Global Technical Regulation No. 16 (Tyres)

IWG Tyre GTR Proposal for Amendment No. 2 (phase 2A)

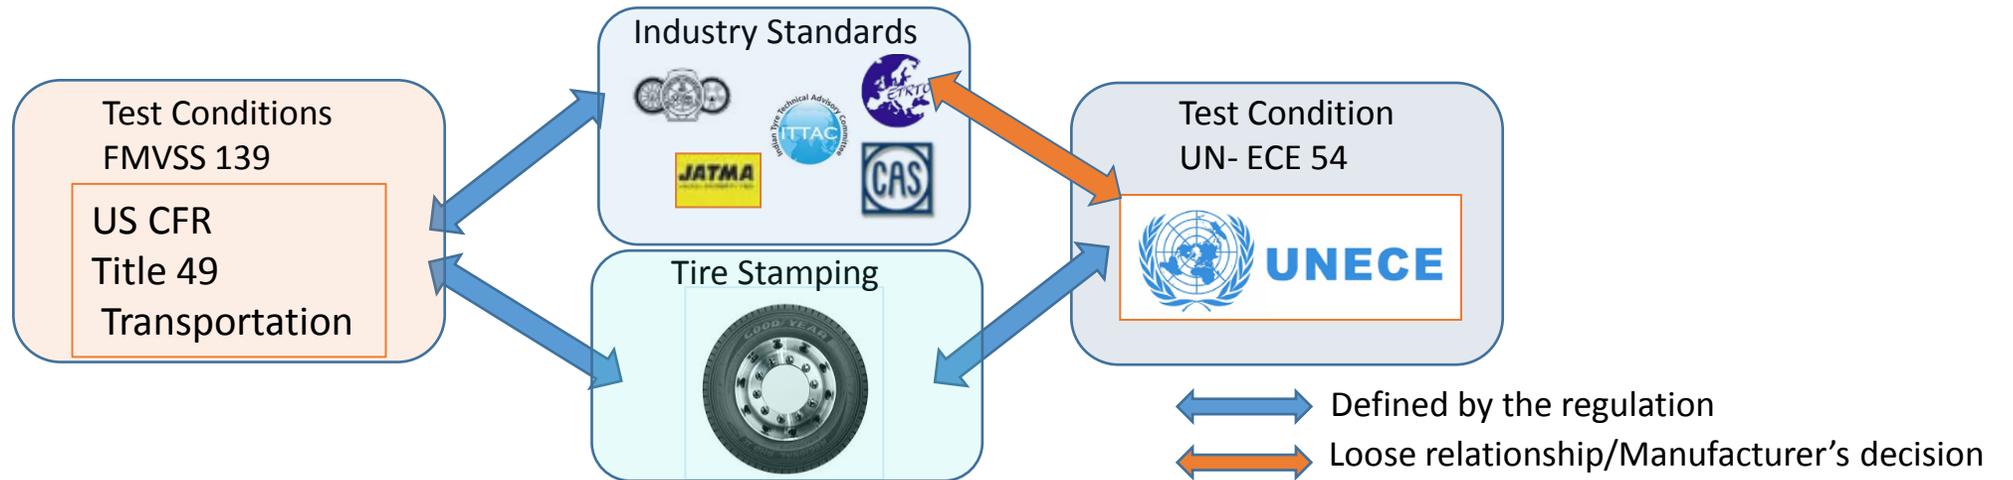
Physical dimension for high flotation sizes (excluding all sizes listed in Annex 6)
Requirements as per WP.29/GRRF/2018/5 amended by GRRF-86-26,
subject to approval by GRRF and adoption by WP.29

Industry proposal, ECE R54 Test inflation pressure

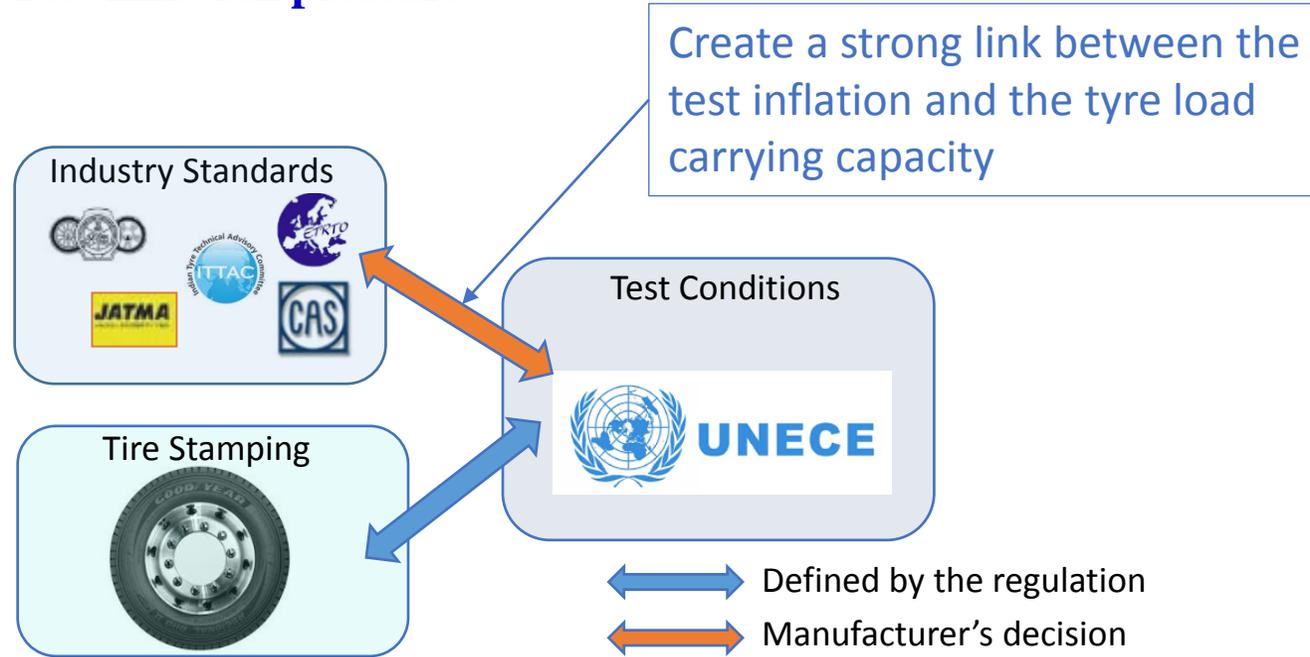
Proposal:

2.56 Reference Test Inflation Pressure applicable for LT/C tyres is the minimum cold inflation pressure for the maximum load carrying capacity of the tyre. [for single application]
